Mountaineer Bottom Ash Complex Report

Lockheed Martin
Contractor for the USEPA

December 2009

BOTTOM ASH COMPLEX PLAN DIAGRAM

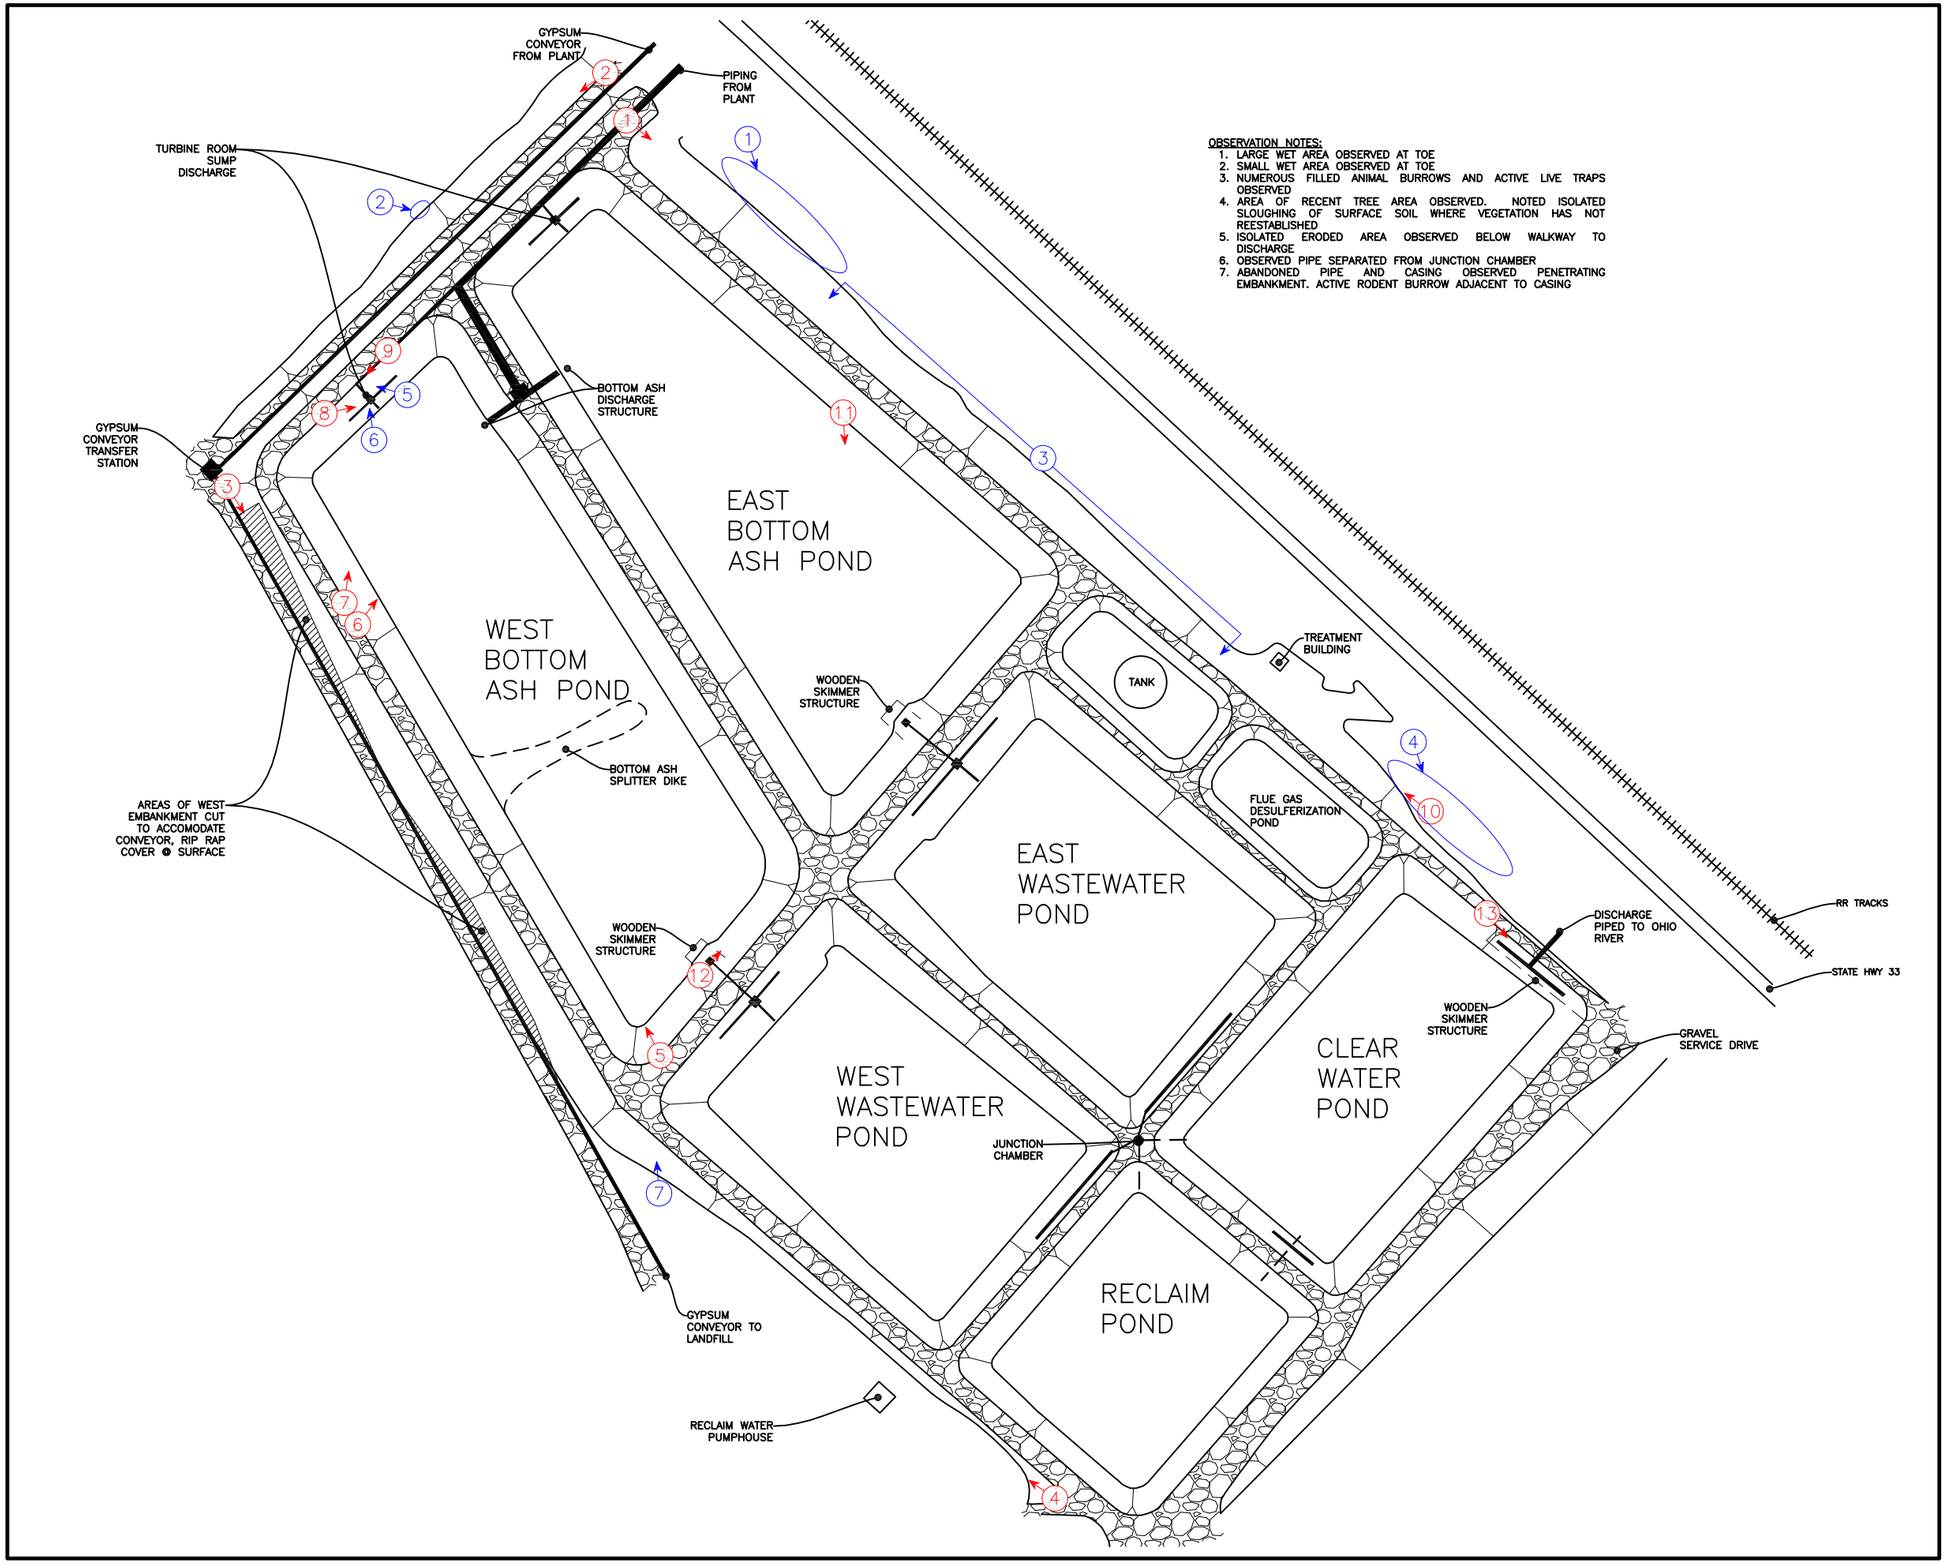
The following is a summary of observations made during the visual inspection. Figure 3 depicts the locations of the observations listed below.

- Tall, weedy vegetation on the outboard slopes of the east and west dike embankments inhibited close inspection. Past vegetative growth and maintenance activities have left the slopes with numerous surface irregularities.

- A large wet area was observed at the toe of the north portion of the east embankment (Appendix B – Photo 1).
- A small wet area was observed at the toe of the central portion of the north embankment (Appendix B – Photo 2).

- Animal burrows were observed at numerous locations on the east embankment. Most burrows were recently filled and live traps were observed at various locations.

- Isolated sloughing of surface soil was observed along the east embankment where trees and shrubs were recently removed. The sloughing was observed occurring in locations where vegetative cover had not yet reestablished (Appendix B – Photo 10).

- An isolated eroded area was observed on the in-board slope of the north dike embankment near the crest roadway and below the walkway to the Turbine Room Sump Discharge into the West Bottom Ash Pond. The eroded area extended the full length of the slope, deepening to a gully more than one foot deep near the bottom of the slope (Appendix B – Photo 9).

- The Turbine Room Sump Discharge chamber in the West Bottom Ash Pond was observed to have separated from the west manifold pipe. The discharging water was roughly surging out of the separation and beginning to erode the soil behind the chamber, connecting with the erosion described above (Appendix B – Photo 8).

- An abandoned pipe and casing were observed in the central portion of the west embankment. An active rodent burrow was observed adjacent to the casing.

OBSERVATION NOTES:
1. LARGE WET AREA OBSERVED AT TOE
2. SMALL WET AREA OBSERVED AT TOE
3. NUMEROUS FILLED ANIMAL BURROWS AND ACTIVE LIVE TRAPS OBSERVED
4. AREA OF RECENT TREE AREA OBSERVED. NOTED ISOLATED SLOUGHING OF SURFACE SOIL WHERE VEGETATION HAS NOT REESTABLISHED
5. ISOLATED ERODED AREA OBSERVED BELOW WALKWAY TO DISCHARGE
6. OBSERVED PIPE SEPARATED FROM JUNCTION CHAMBER
7. ABANDONED PIPE AND CASING OBSERVED PENETRATING EMBANKMENT. ACTIVE RODENT BURROW ADJACENT TO CASING

Erosion of the dike embankment crest and slope at the Turbine Room Sump Discharge into the West Bottom Ash Pond should be repaired, including measures to prevent runoff from accumulating on the crest and being channeled to this location. The connection of the Turbine Room Sump discharge header to the junction chamber should also be restored to prevent pond slope and bottom erosion around the junction chamber.

Additional efforts should be taken to re-establish vegetation on the outboard embankment slope of the east dike where trees were recently removed.

The abandoned pipe casing penetrating the west embankment should be sealed as recommended by WVDEP and AEP corporate engineering.

The facility should consider more frequent maintenance of vegetation on the dike embankment slopes to facilitate inspection and promote a denser and more uniform vegetative cover.

Photo Number: 8

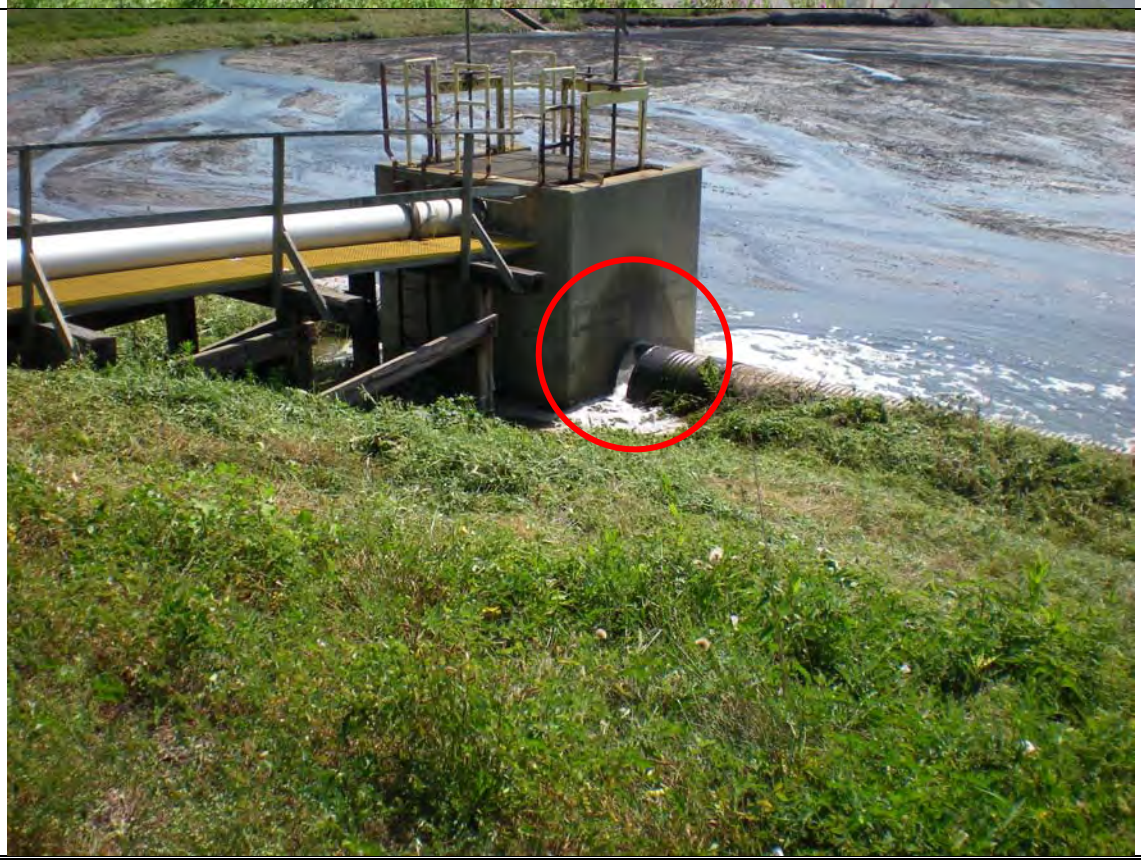
Description: Close up of Turbine Room Sump discharge junction box. Note pipe separated from junction box.

The minor crest erosion and Turbine Room Sump Discharge chamber at the West Bottom Ash Pond should be closely monitored during the monthly plant inspections.

For repair of the erosion and Turbine Room Sump Discharge chamber in the West Bottom Ash Pond, the West Bottom Ash Pond could be allowed to finish its annual service cycle. The repair should be completed prior to reinstating the West Bottom Ash Pond into service for its next annual cycle. Should the condition of this area be observed to significantly worsen prior to the end of the annual service cycle, the area should be repaired immediately.
